## **IMPORTANT RECALL INFORMATION #70131**

**SUBJECT: RECALL CAMPAIGN #70131**  
American Eagle and American Tradition ABS Module

# Recall Bulletin 70131

**SUBJECT:**  
Permanently  
mounting the  
Anti-Lock Braking  
System (ABS)  
module

Figure 1

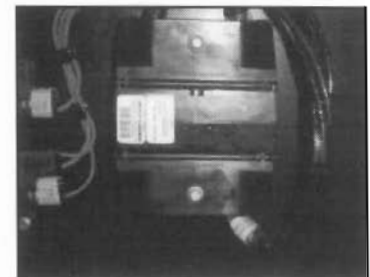
The ABS braking module may not have been permanently mounted during the production process. If the ABS braking module becomes detached, the braking system will continue to operate; however, the anti-lock feature will not function.

A. If the ABS braking module is present and is secured to the wall of the luggage compartment, no further work is required. See Figure 1.

B. If the ABS braking module is not located in the luggage compartment, follow the procedure below to re-locate the module and permanently mount it under the motor home to the chassis bridge structure.

**Figure 2**

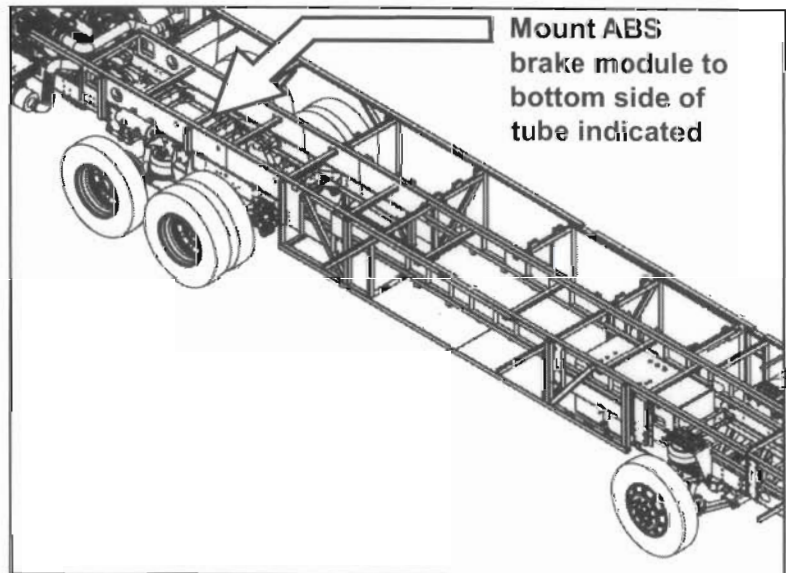
3. Cut the wire ties attaching the ABS braking module to the wiring and hoses inside the chassis rail.
4. Remove the temporary tag that states: "THIS ITEM IS TEMPORARILY MOUNTED AND IS TO BE PERMANENTLY MOUNTED BY BODY MANUFACTURER."
5. Loosen the two screws attaching the cover to the ABS braking module using a 10 mm socket. The ABS braking module attachment holes will be visible. See Figure 2.

**NOTE:** The cover screws will loosen but will remain attached to the cover.

6. Attach the ABS braking module to the chassis bridge structure with (two) #12-14 X 2" tek screws. See Figure 3.
7. Tighten the screws on the ABS braking module cover.
8. Use heavy duty wire ties to secure all wires, including ABS braking module wires that are above the drive shaft. Trim off excess wire tie length as necessary.
